MEMORANDUM

FROM: Johannes Pfeifenberger and Bin Zhou, The Brattle Group

SUBJ: ATWACC Update for PJM CONE Analysis

DATE: August 21, 2018

Figure 1. Comparison of Brattle ATWACC Recommendations (2018 Column Represents the Current Update)

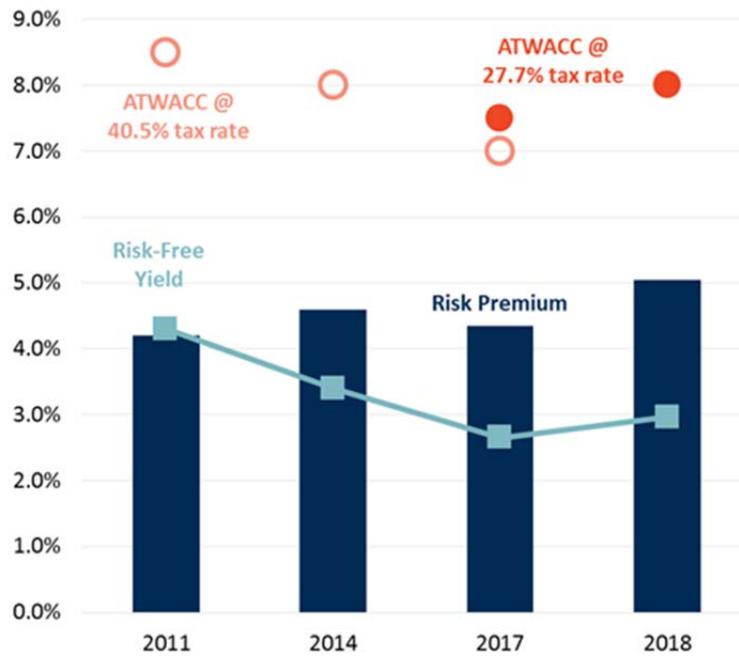
Figure 1 (update of Figure 6 in the report) presents our 2018 update of the ATWACC (on the very right) and implied ATWACC premiums above the risk-free rate together with our recommendations from previous CONE studies, including the original 2017-based recommendation in our current CONE analysis (the 2011, 2014 and 2017 data are from the original Figure 6). Corresponding to our updated 2018 ATWACC recommendation, the “risk premium” of the ATWACC recommendation over the risk-free rate (20-year Treasury bond

rates) is now about 5.0%, which is higher than the approximately 4.5% risk premiums of the ATWACCs used in our prior recommendations.⁷

Second, if one were to conduct a historical benchmarking analysis, a more straightforward way is to compute the ATWACC premium over the risk-free rate (as we have done in Figure 1 above). At Energyzt’s recommended ATWACC of 9.7%, the resulting ATWACC premium above the risk free rate would be 6.7%, well above the premium that existed in the 2014 recommendation.

Figure 2. ATWACC of U.S. IPPs and Discount Rates from Fairness Opinions as of Nov 2017 (35% Federal Tax Rate)

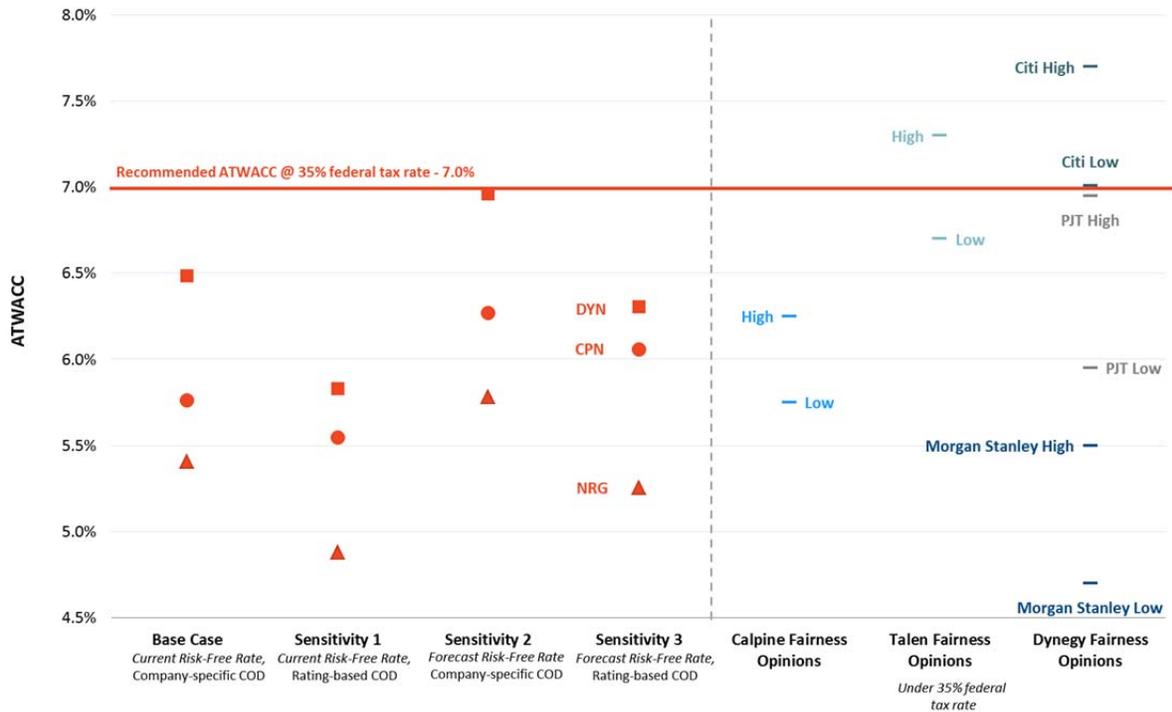
The starting point of our ATWACC analysis is the quantification of business risks in the U.S. merchant generation business from the market evidence. In our original analysis, consistent with our analyses in previous PJM CONE reports, we examined (1) a sample of U.S. independent power producers (IPPs); and (2) ATWACC-based discount rates used by financial analysts in evaluating recent merchant generation M&A transactions. We also considered a sample of Canadian IPPs in our current PJM CONE report, since two of the U.S. IPPs were acquired. In recognition of higher merchant generation risks compared to the average risk of (partly contracted) IPP portfolios, we recommended an ATWACC at the very high end of the ranges associated with these merchant generation company reference points. In January 2018, this yielded an ATWACC of 7.0% under the 35% federal corporate income tax rate (consistent with Figure 2 above) and 7.5% as a result of the lower tax rates.

yet reflect the impact of the new tax law. Even when including these new data, we believe the original 7.0% applicable under the 35% tax law as shown in Figure 2 is still the most reasonable estimate, as of November 2017. (Our view of ATWACC recommendations obtained from potential lenders as presented to PJM by Energyzt is discussed below.)

There are two necessary adjustments to the 7.0% ATWACC estimate in Figure 2. First, we increased the ATWACC from 7.0% to 7.5% to incorporate the changes in the new tax law. This adjustment was already included in our original recommendation. Second, we now also incorporate new data showing that the risk-free rate and cost of debt have increased since our original work:

**Figure 3. ATWACC under Current Interest Rates
(21% Federal Corporate Income Tax Rate)**

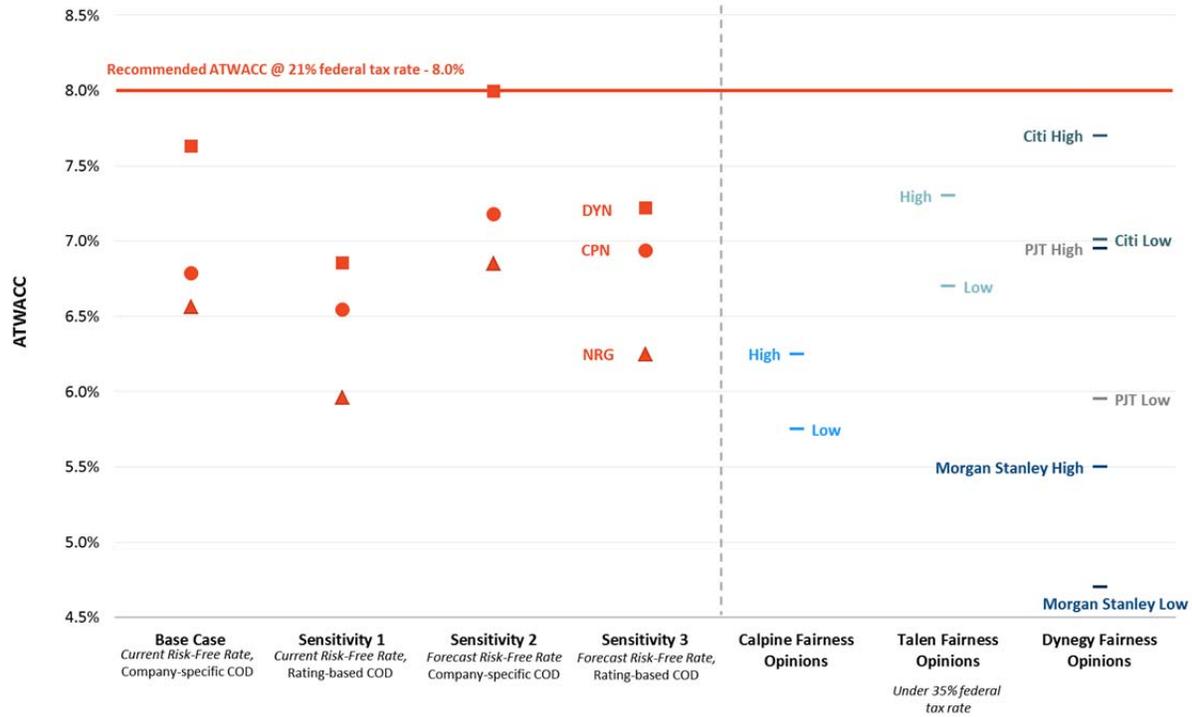
The resulting updated ATWACC estimates for the U.S. IPPs, including the discount rates disclosed in the most recent fairness opinions (which do not reflect the lower federal corporate income tax rate), are shown in Figure 3. Our Base Case and three Sensitivity Cases reflect different combinations of risk-free rates (current v. forecast) and costs of debt (ratings-based v. company-specific) as described in the full report. Based on these updated reference points, we recommend 8.0% as our updated ATWACC.
